INVITATION TO BID NO. 21-DPR-ITB-673

ADDENDUM NO. 2

Arlington County Invitation to Bid No. 21-DPR-ITB-673 for Construction of Thomas Jefferson Upper Field Turf Conversion is amended as follows:

SCALE: HORZ 1" = 20'
VERT. 1" = 2'

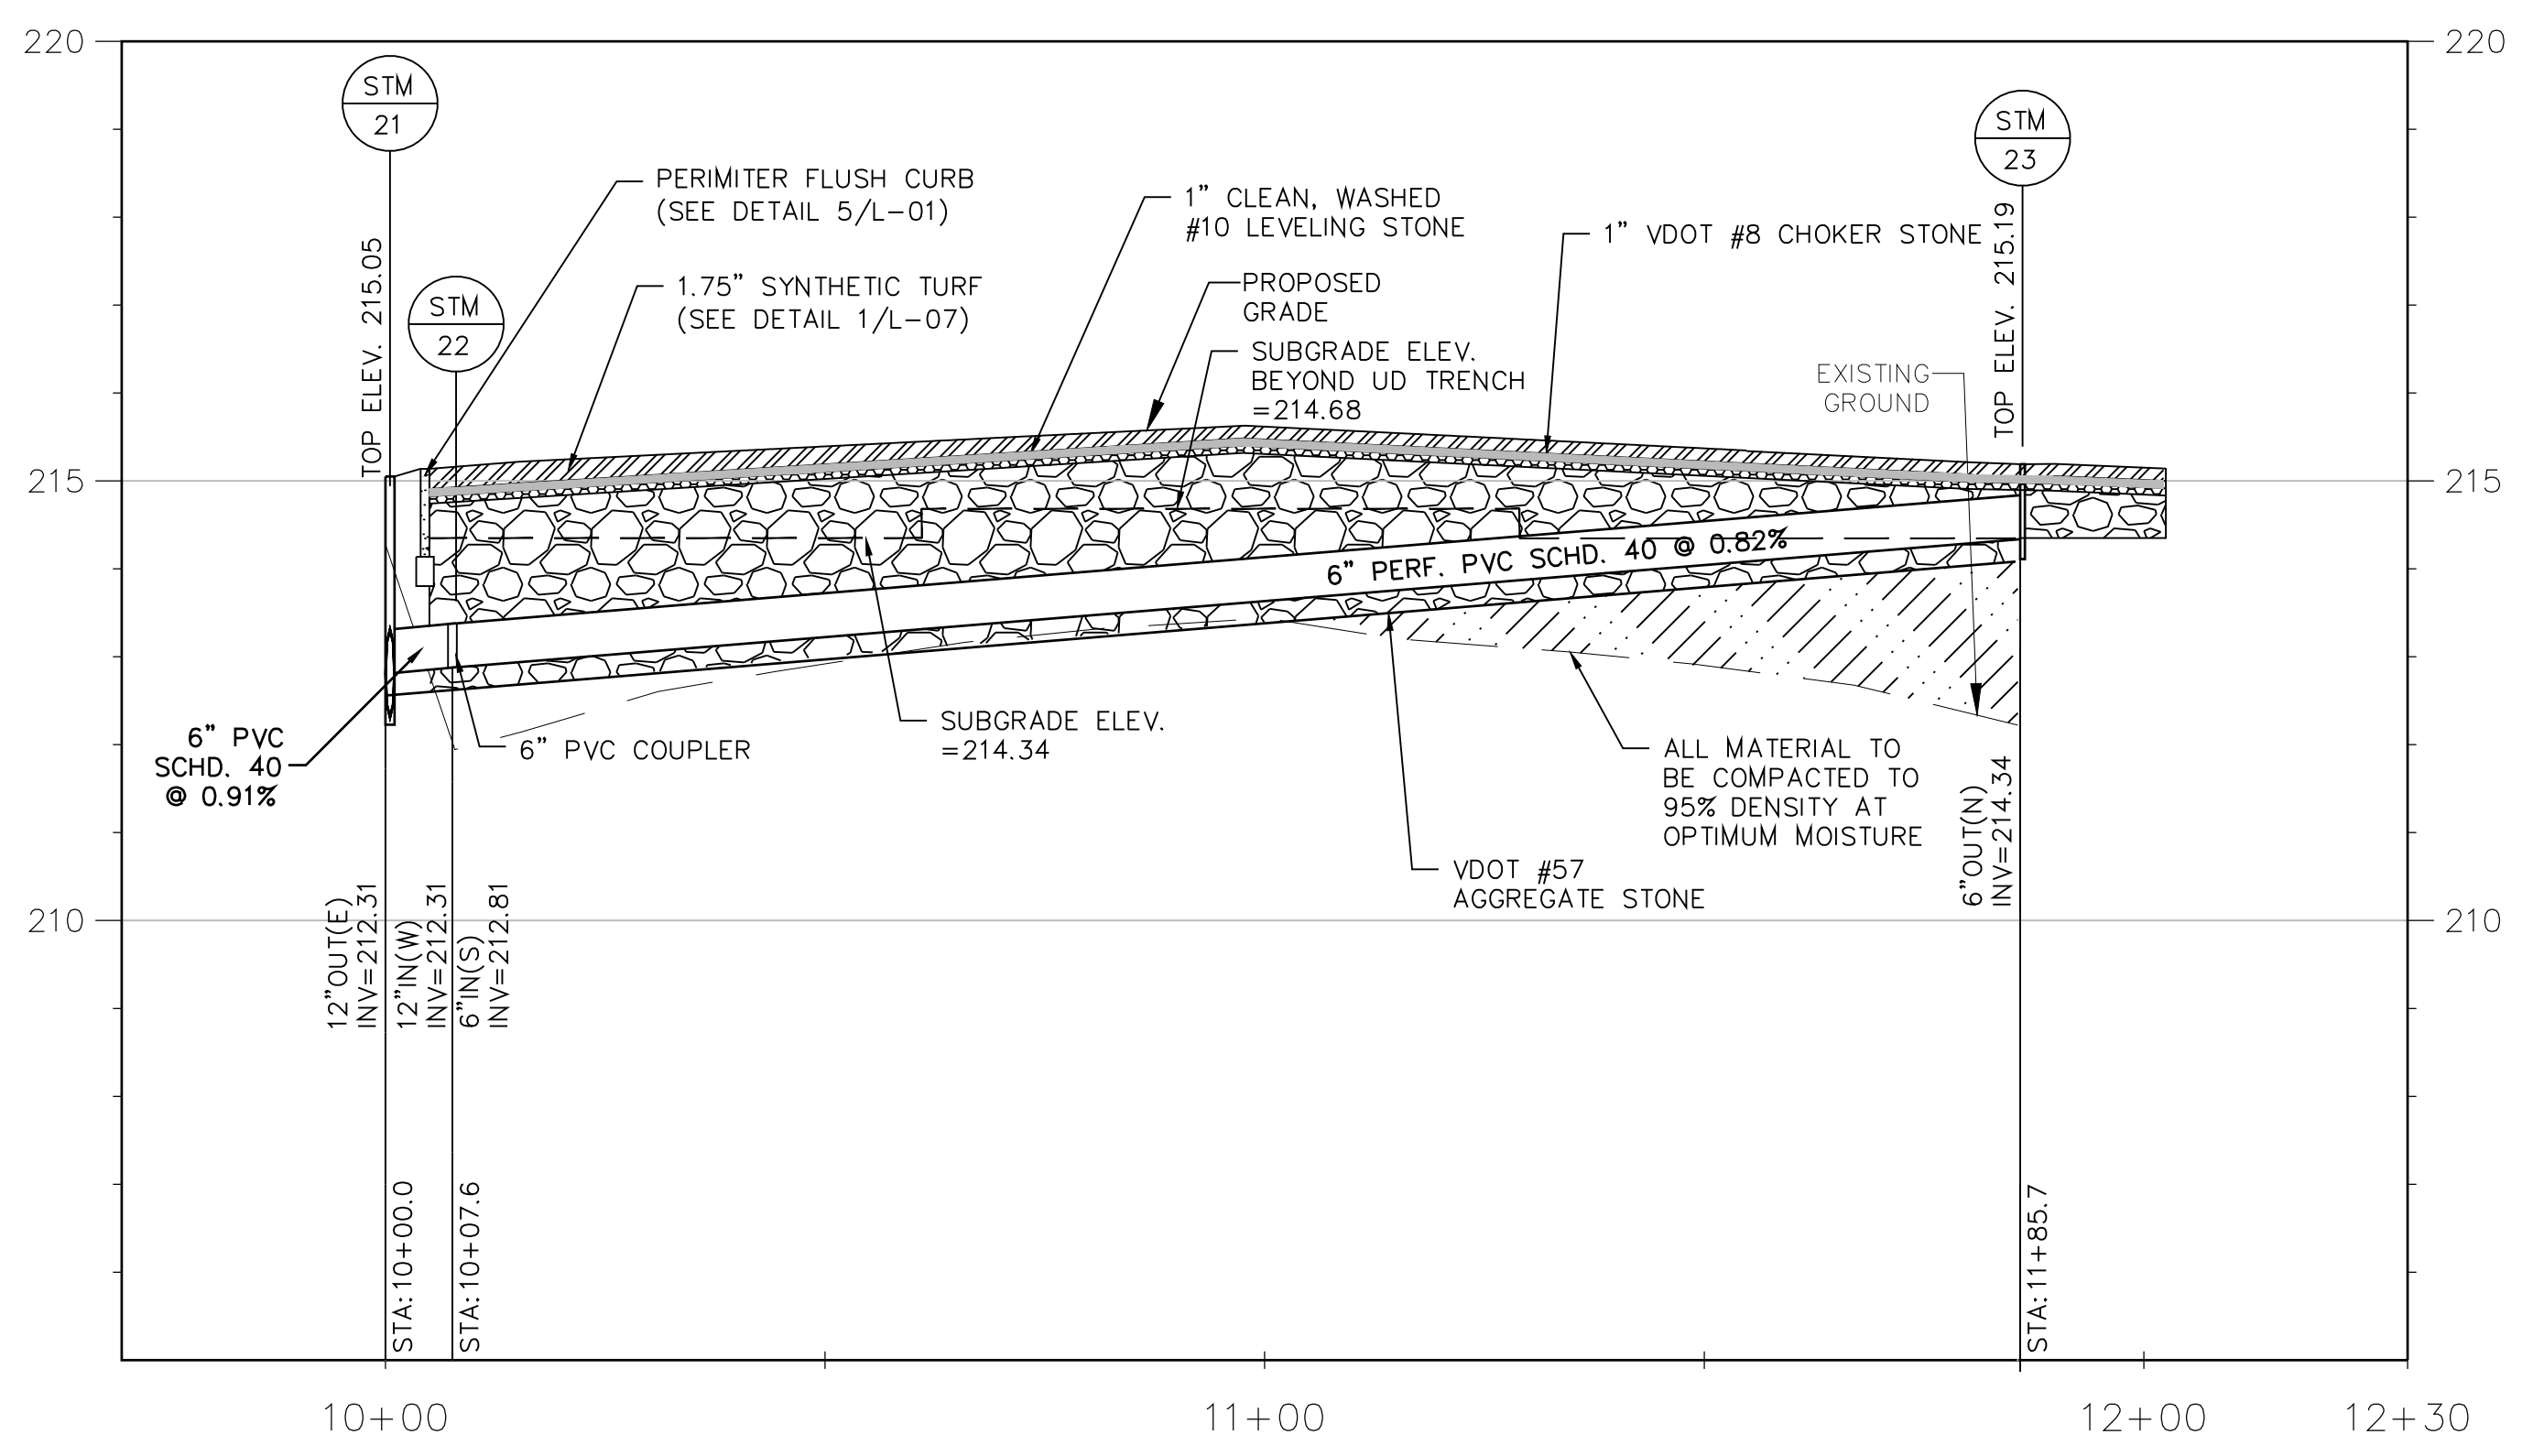
6. **Question: Drawing C15 to C15B have "???" symbols on the storm structure profile and do not identify the storm structure's locations. Please provide drawing for the storm structure profiles and locations.**

Answer: Sheets C-01, C-04, C-11, C-15, C-15A and C-15B have been revised. See attached (Attachment D - Addendum 2 Plans.pdf)
